**Development Application No: 54602/2018
Land Zoned: R1 GENERAL RESIDENTIAL
Property: LOT DP: 45551, LOT: 100 DP: 1075037 No 87
John Whiteway Drive GOSFORD, 89 John
Whiteway Drive GOSFORD**

OBJECTIONS TO THE PROPOSED DEVELOPMENT APPLICATION 54602/2018 FOR 262 UNITS ON SITE DESIGNATED 87-89 JOHN WHITEWAY DRIVE AMENDED PLANS.

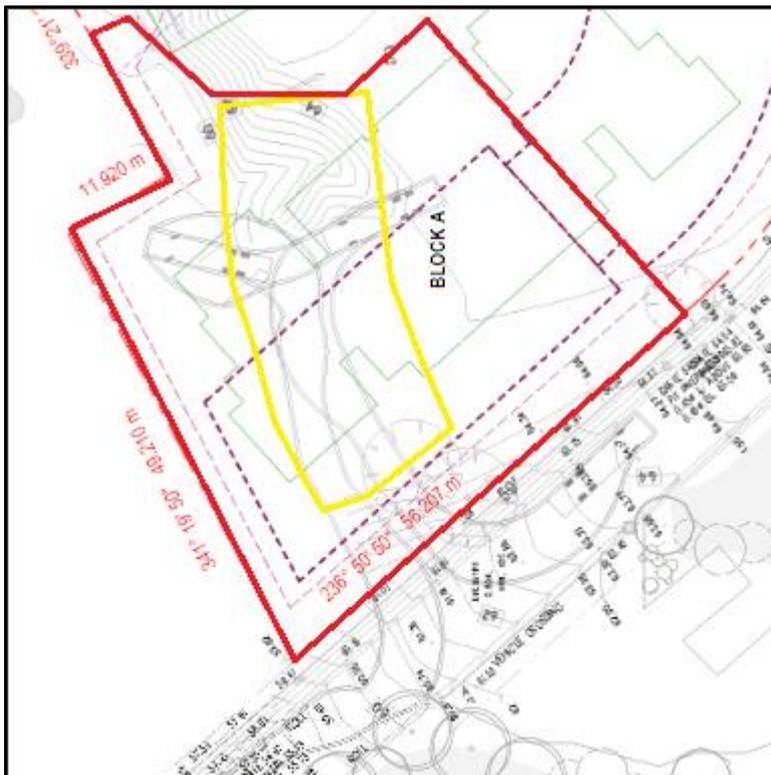
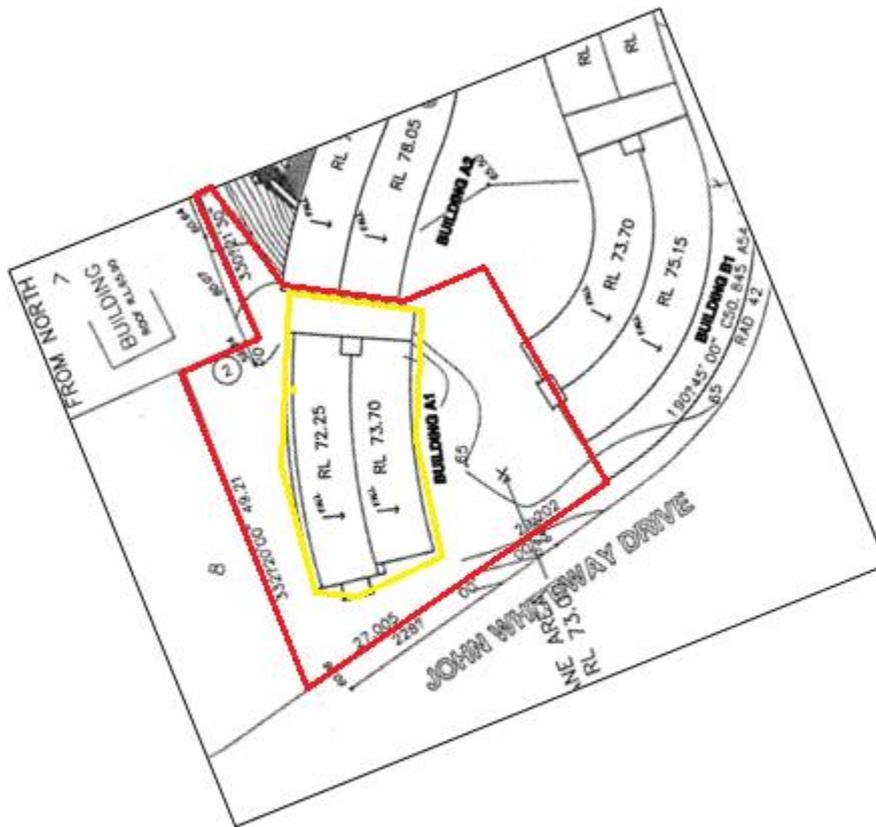
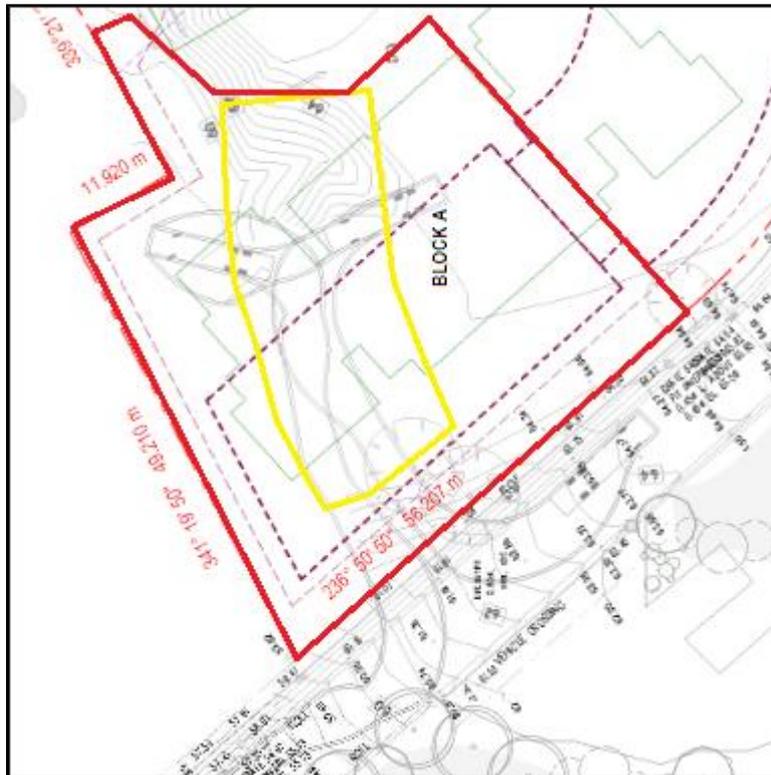
Looking at the two previous pictures, the yellow highlighted area represents the removed Building A1.

The subsequent approval dated 15/06/2004 shows, along with the yellow highlighted area, the dashed outline of this approval.

The red highlighted area on both pictures indicates the area that after Building A1 has been removed, where there would no buildings at all advice and letter from the developer to Council.

- The dashed outline is what was subsequently approved on 15/06/2004, with the approval stating the following:
 - *Having regard to the provisions of Section 96(1)(a) of the Environmental Planning and Assessment Act, 1979, the Council is of the opinion that the proposed amendment **is a minor modification and the development is substantially the same** as that approved under Notice of Determination dated 13 February 2004.*

- How can the red text above be justified and accepted by Council when as directed by the developer in the interests of the neighbouring Panorama Towers, that the yellow highlighted area be removed. As such, viewing the dashed outline in context of the vacant red highlighted area can in no way in anyone's opinion be deemed a minor modification and substantially the same.

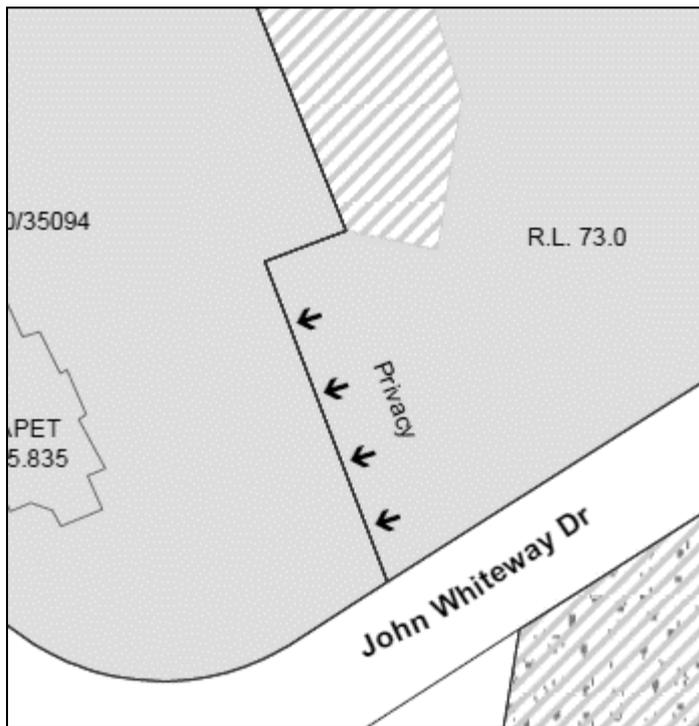
- This then is our objection that the new proposal drawings showing their proposed building (Block A) to not be that different to the previous erroneous approval identified by the dashed outline. When the dashed outline should not have been approved and therefore not exist in this application. The new proposed Block A should therefore not be part of this application.
- The proposed Block A is of great concern and detriment to neighbouring apartment owners in Panorama Towers.
- Below is an excerpt from the Gosford DCP showing clearly that there should and must be a consideration by developers and Council for the privacy of the property owners of Panorama Towers.
